Addendum #1
City of Portsmouth
Portsmouth, New Hampshire
Public Works Department

WEST ROAD RECONSTRUCTION
City of Portsmouth Project #7200
Bid Proposal #15-16

This addendum forms part of the original document titled: Bid Proposal #15-16, West Road Reconstruction

SHEET NUMBER:
C.4

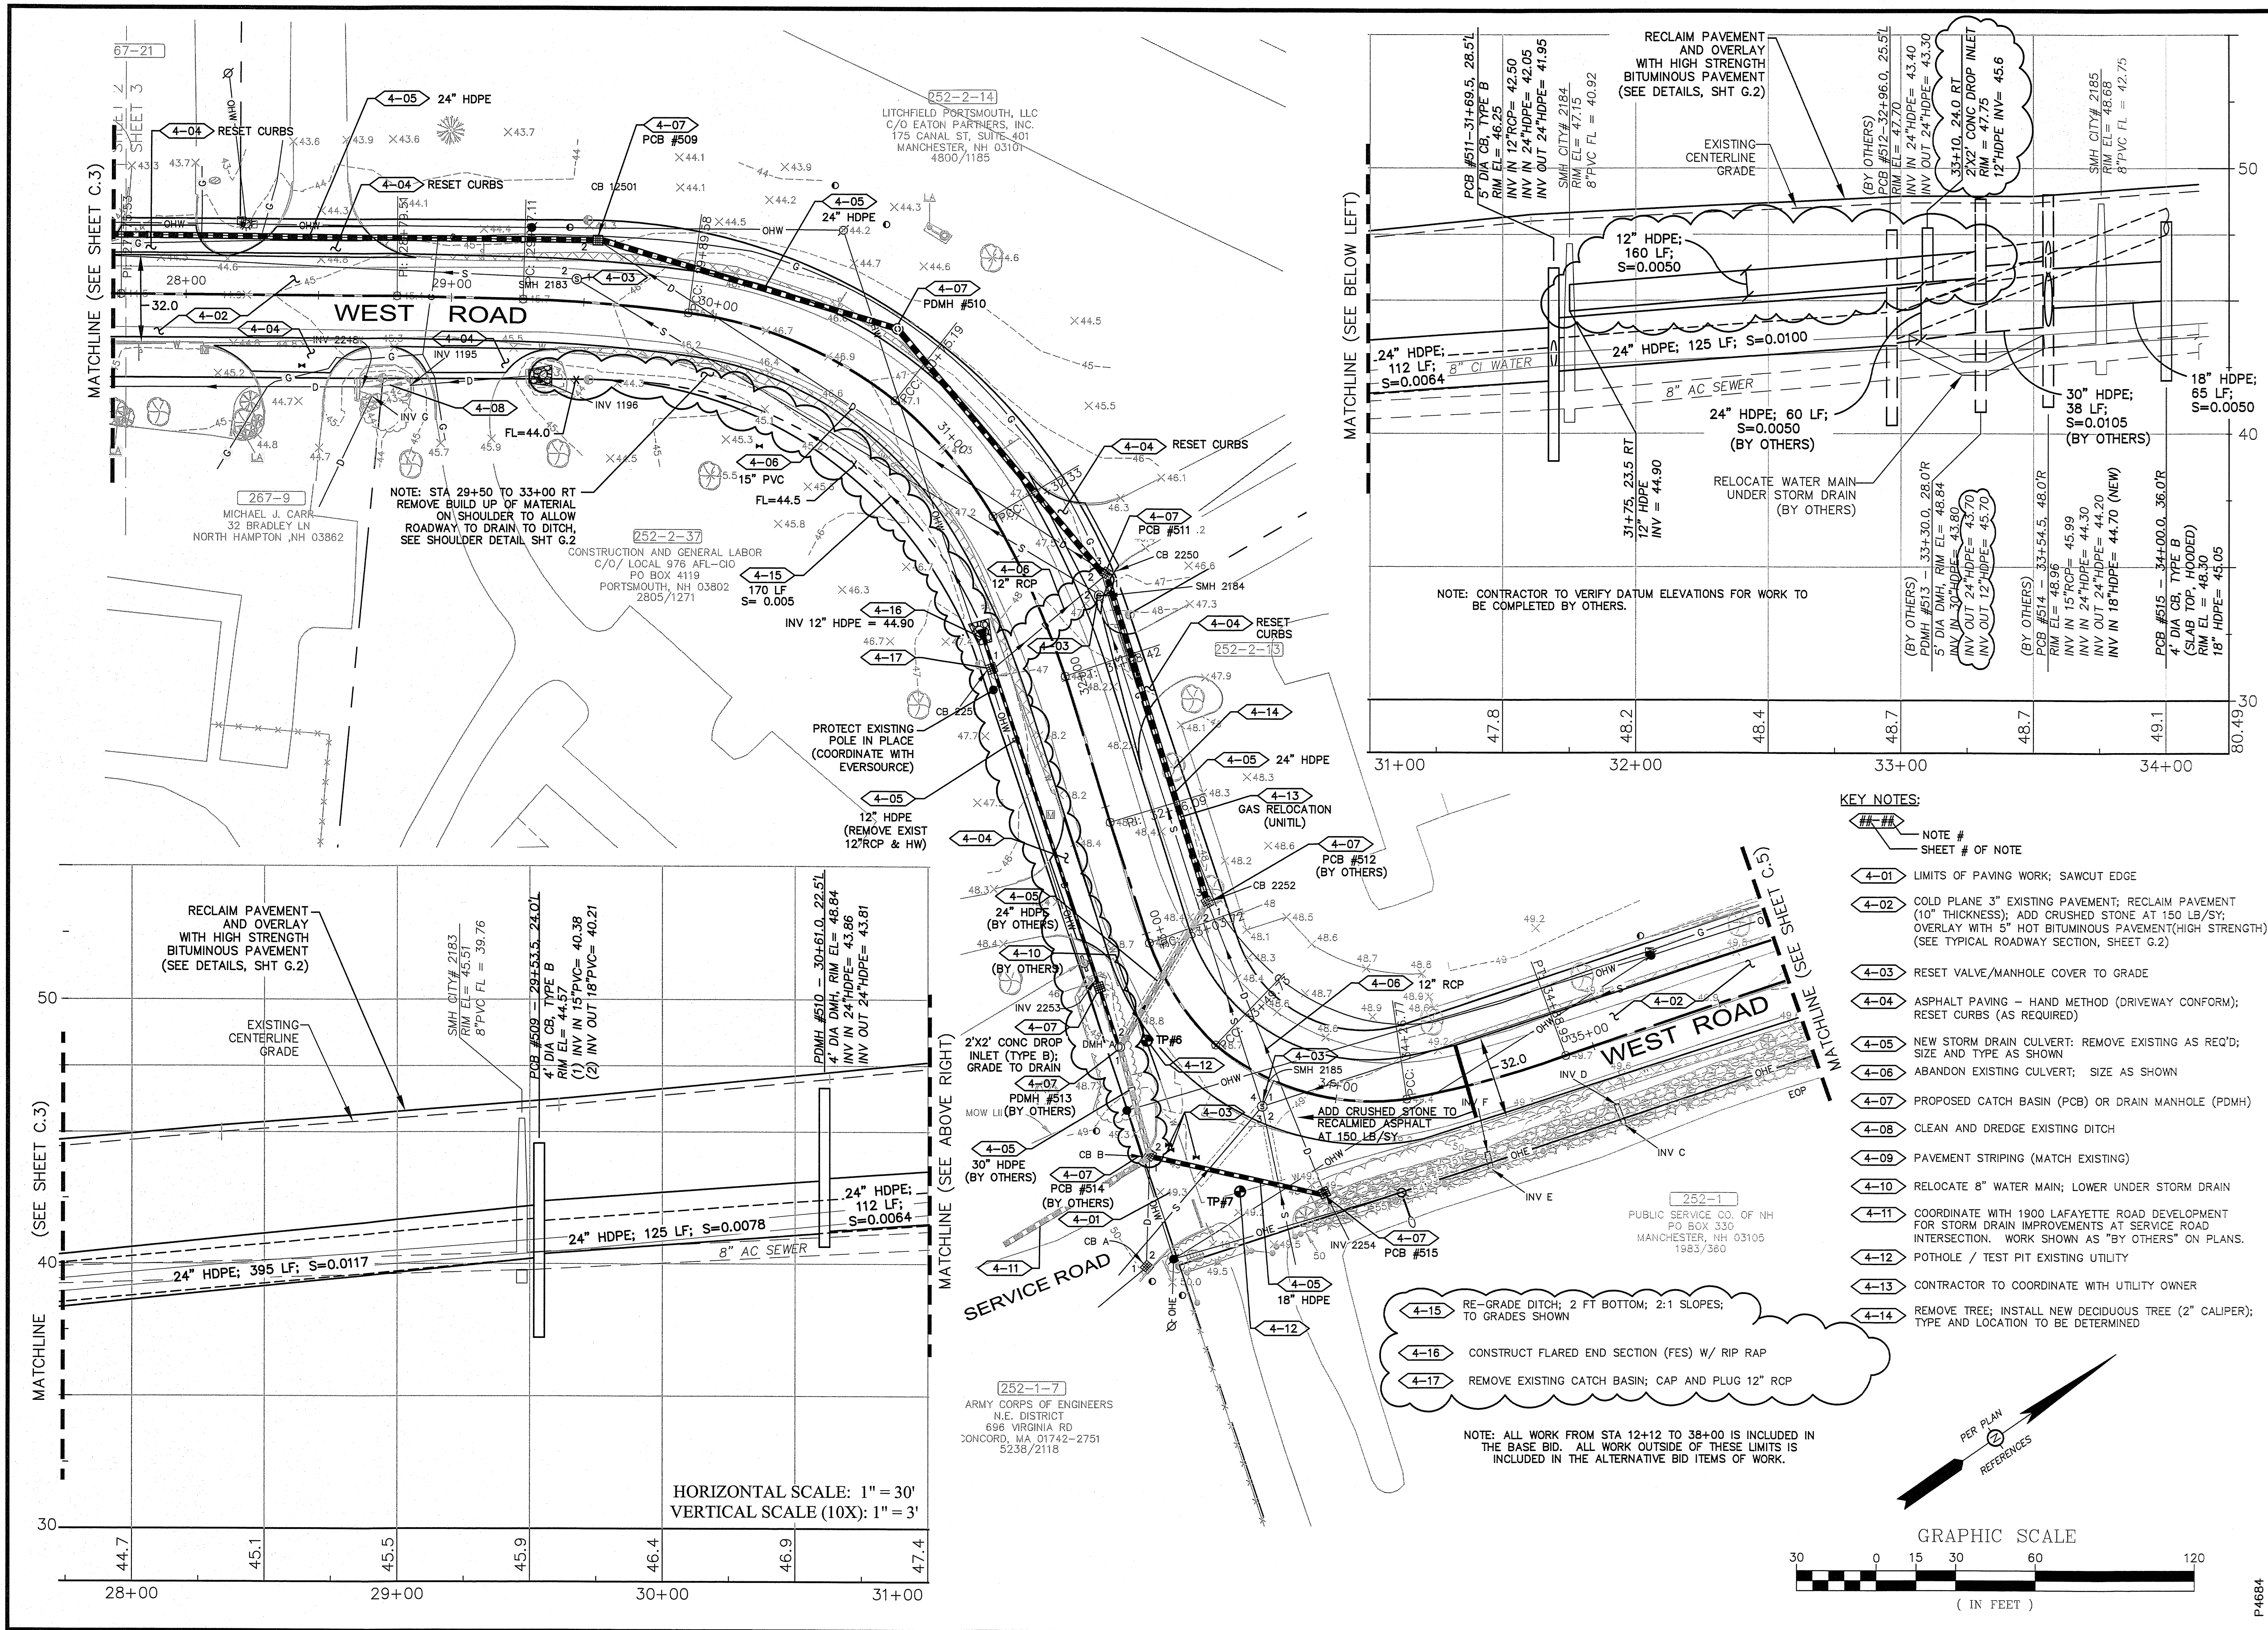
1. Plan Change: Sheet C.4 is replaced with the revised sheet dated September 14, 2015. This sheet illustrates the changes to the proposed storm drain system and includes, but is not limited to, the following additional items of work:
 - Install 160 LF of new 12" HDPE with Metal FES and Rap Rap outlet protection, West Road Sta 31+75 to 33+30 Rt, connect to PDMH #513 (being installed by others).
 - Install a 2' x 2' Conc. Drop inlet (Type B) at approximately Sta 33+10 Rt, connecting to PMDH #513 (being installed by others)
 - Remove existing 12" RCP, West Rd Sta 31+90 to 33+05 Rt.
 - Remove existing catch basin #2251.
 - Abandon 12" RCP cross culvert, West Rd Sta 31+80, plug and cap ends.
 - Re-grade ditch with 2 ft wide bottom and 2:1 max side slopes, West Road Sta to 29+40 to 31+75.

A. 27” HDPE Pipe – Changed to 27” PVC Pipe

The project plans identify 27” HDPE pipe from approximately Station 22+00 to 23+75 LT. The 27” HDPE pipe should be revised to 27” PVC Pipe. The Bid Proposal Sheet has been revised to reflect this change.
